SECTION AT FRAME Nº 188 LOOKING AFT.
PLAN VIEW OF PUMP RECESS PORT SIDE ONLY SCALE ½" = 1 FOOT
SECT A-A PORT SIDE ONLY
STR. Nº 810-811
AFTER FRAMES
Nº 188 - 203
PRINT Nº
ISSUED

DRAWING
Nº 58
SCALE: ¼" = 1 FOOT
DATE: JULY 16, 1937
TRACING
Nº 810-811-58
A.M.S.B.Co.

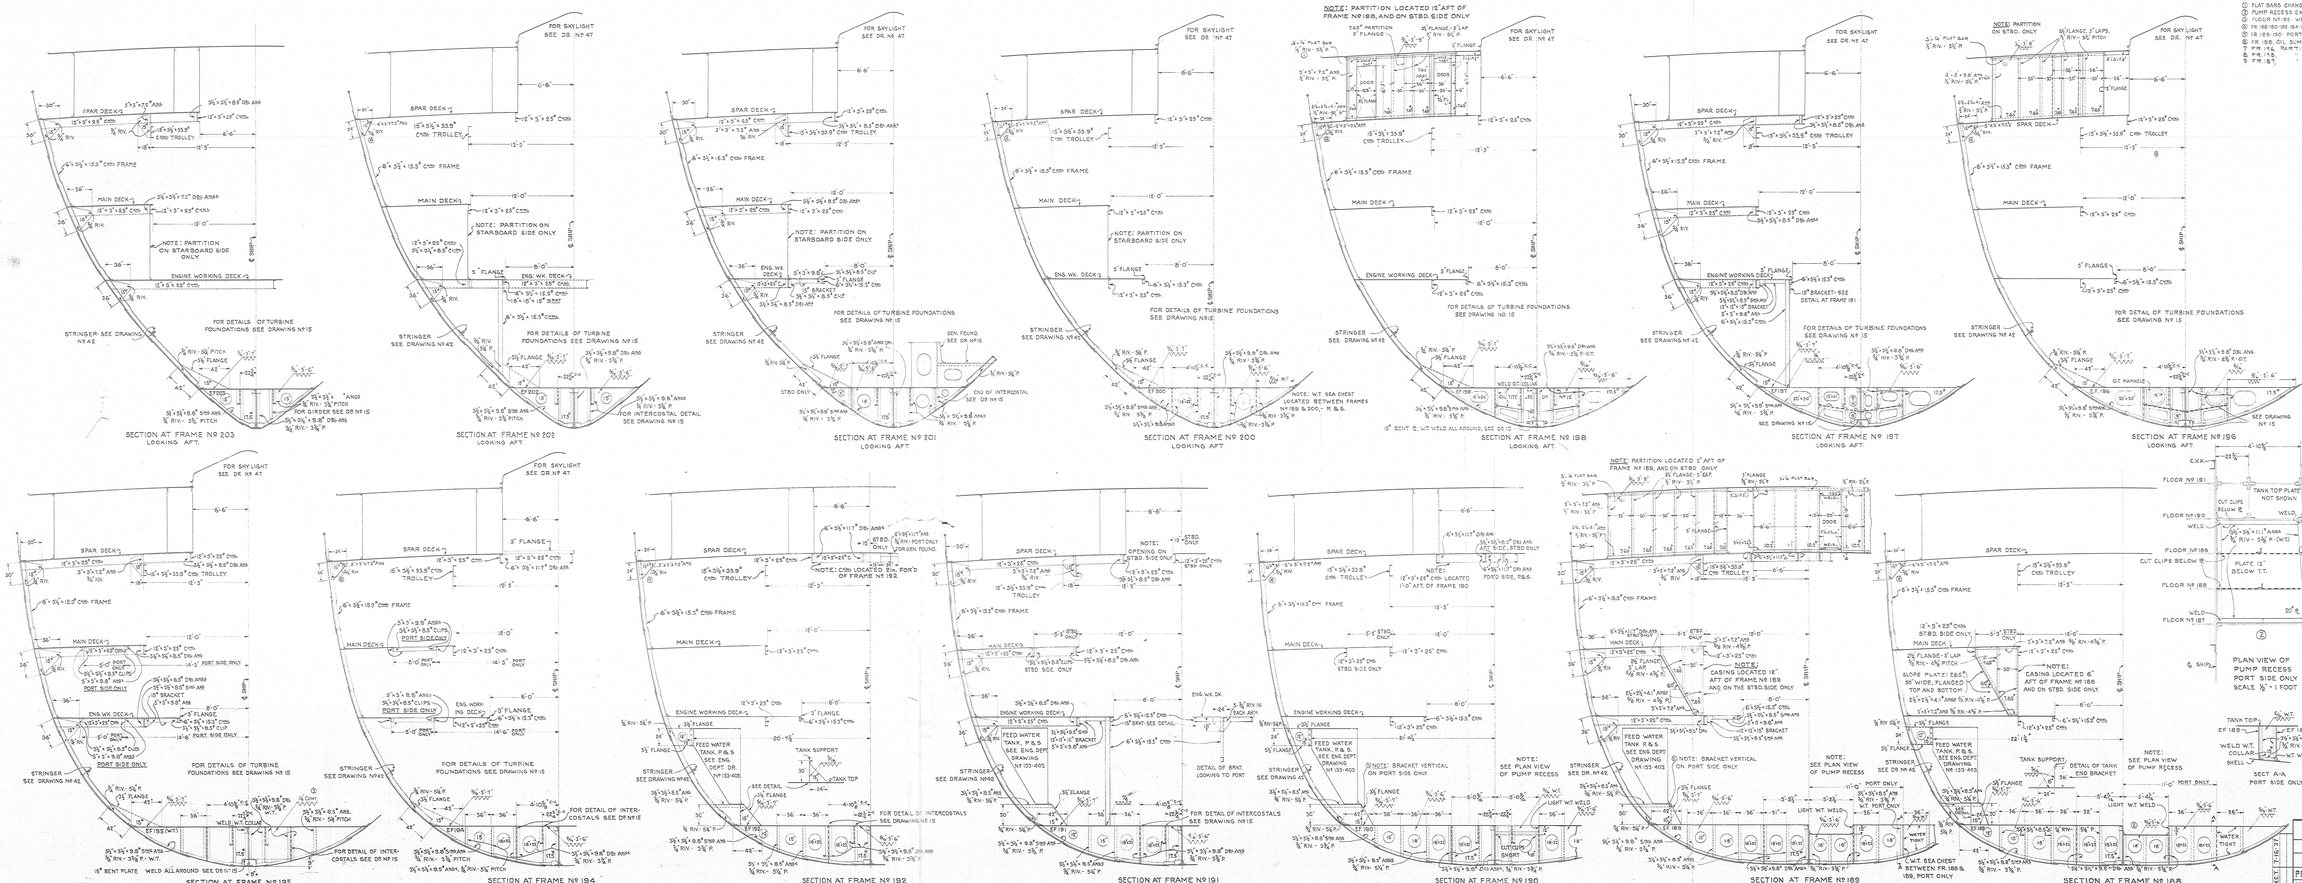
RECORD OF CHANGES
① FLAT BARS CHANGED TO ANGLES 7-17-37
② PUMP RECESS EXTENDED TO 187 7-19-37
③ FLOOR Nº 85 WELD CHANGED 7-22-37
④ FR. 188-190-192-194-196-198-200-202 BRACKETS ADDED 7-23-37
⑤ FR. 189-190 - PORT PIPE TANK SUPPORTS CHANGED 7-22-37
⑥ FR. 188, OIL SUMP MOVED TO STBD. SIDE 7-22-37
7 FR. 1-5, PARTITION CHANGED 8-24-37
8 FR. 1-5, 8-24-37
9 FR. 18-5, 8-24-37
NOTE: PARTITION LOCATED 12" AFT OF FRAME Nº 188, AND ON STBD. SIDE ONLY
SECTION AT FRAME Nº 203 LOOKING AFT.
SECTION AT FRAME Nº 202 LOOKING AFT.
SECTION AT FRAME Nº 201 LOOKING AFT.
SECTION AT FRAME Nº 200 LOOKING AFT.
SECTION AT FRAME Nº 198 LOOKING AFT.
SECTION AT FRAME Nº 197 LOOKING AFT.
SECTION AT FRAME Nº 196 LOOKING AFT.
SECTION AT FRAME Nº 195 LOOKING AFT.
SECTION AT FRAME Nº 194 LOOKING AFT.
SECTION AT FRAME Nº 192 LOOKING AFT.
SECTION AT FRAME Nº 191 LOOKING AFT.
SECTION AT FRAME Nº 190 LOOKING AFT.
SECTION AT FRAME Nº 189 LOOKING AFT.
